**Project #22-057
The Logan Silos
Located at 280 West 300 South**

Project Name: The Logan Silos
Proponent / Owner: Tim Rodebush / The Logan Silos LLC
Project Address: 280 West 300 South
Request: Design Review Permit
Current Zoning: Mixed Use (MU)
Type of Action: Quasi-Judicial
Hearing Date: October 27, 2022
Submitted By: Tanya Rice, Planner II

RECOMMENDATION

Figure 1: Project site plan

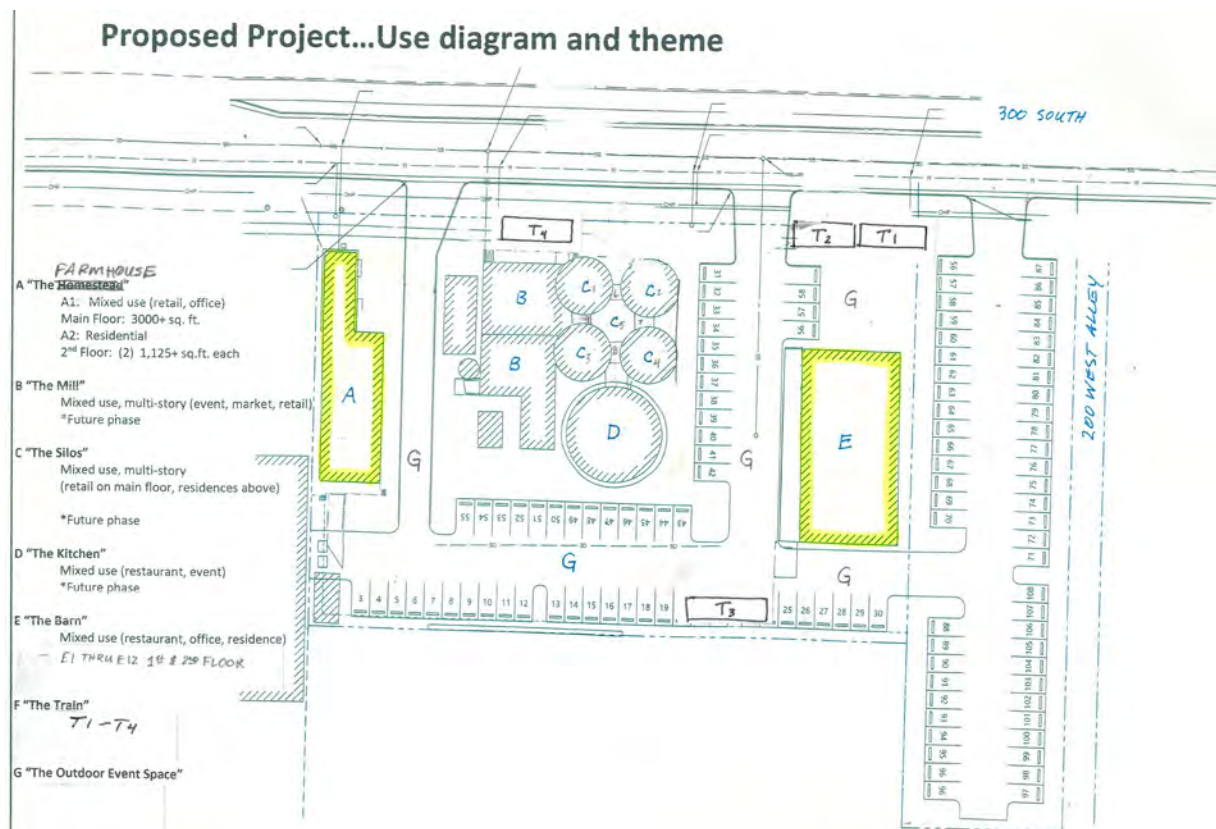
Existing parking areas on the property will be removed and new parking is proposed to the south and east sides of the project. The proposal shows parking within the appropriate setback range. As proposed, parking setbacks meet or exceed the LDC standards.

Vehicular access is provided from 300 South through two (2) existing driveways. The interior parking areas are connected in a 'U' formation around the project site.

The LDC 17.30.160 requires projects to provide safe, direct, and convenient pedestrian connectivity to the street and within project boundaries. The proposed site layout does not show pedestrian circulation and needs further development to show pedestrian connections throughout the development site, connection to future phases of development and pedestrian access points to 300 South and the city sidewalk. As conditioned, the project meets the requirements in the LDC.

The project site does not have existing landscaping or intentional space for outdoor enjoyment nor is there a landscape plan provided with the proposal. The site plan identifies 'Outdoor Event Space' (G on the site plan) which is shown in a drive aisle and parking area, and as such, does not count towards meeting the minimum open space requirements. The frontage along 300 South includes original railroad tracks and the project is intended to maintain the feel of a mill and silo area, so a creative landscaping plan incorporating this area may be appropriate. The site is large enough that all of the minimum land set asides (open space and useable outdoor space) can be accommodated and incorporated into the overall project design. Staff recommends that an overall performance landscape plan is submitted prior to the first building permit specifically identifying open space, landscape plantings, usable outdoor areas and public gathering areas.

3. No parking is permitted between the buildings and 300 South.
4. The project shall provide at least 52 parking stalls that comply with minimum LDC standards.

10. A pedestrian pathway network plan shall be provided with the landscaping plan illustrating pedestrian connections throughout the development, connecting all building entrances, open space and gathering areas, city sidewalks and future phases of development.

Figure 3: East elevation of the Barn

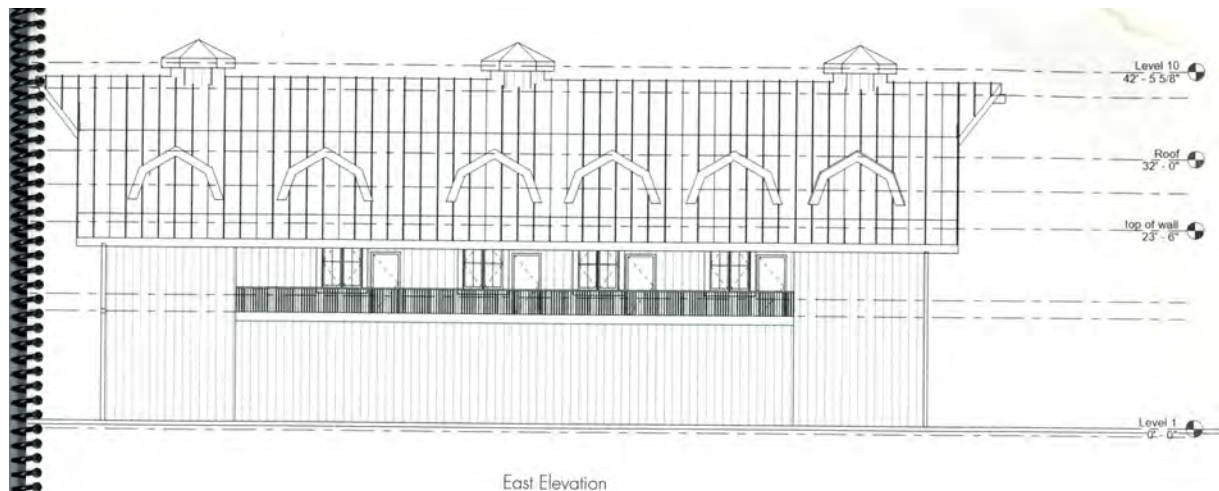
The Barn is currently a concrete building with open storage bays on the west elevation and solid facades on the other sides. This building is 60' back from the sidewalk with rail cars between the Barn and 300 South reducing visibility from the street. The remodel adds a second floor, pitched roof, and wooden siding that resembles a barn building. There is very little variety in color or materials throughout the exterior of the building except for floor to ceiling windows covering the former open bays. Additional windows are added on the north elevation at about 25% transparency. As this is intended for commercial uses and the north side of the Barn is proposed as outdoor event space, staff recommends that the ground floor frontage transparency meet the 50% minimum requirement. The east-facing ground level is proposed as a 100' solid wall that can be seen from 300 South. Staff recommends an additional 20% fenestration as required for exposed side elevations and to break up the 100' wall length. As conditions with adding variation in color and materials to the exterior of the Barn and increasing fenestration on the north and east facades, the Barn meets the requirements of the LDC.

7. Barn ground floor street facing building facade shall meet minimum transparency requirements of 50% on the north façade and 20% on the east façade.
8. The Barn shall add variation in color and/or materials to the exterior facades.
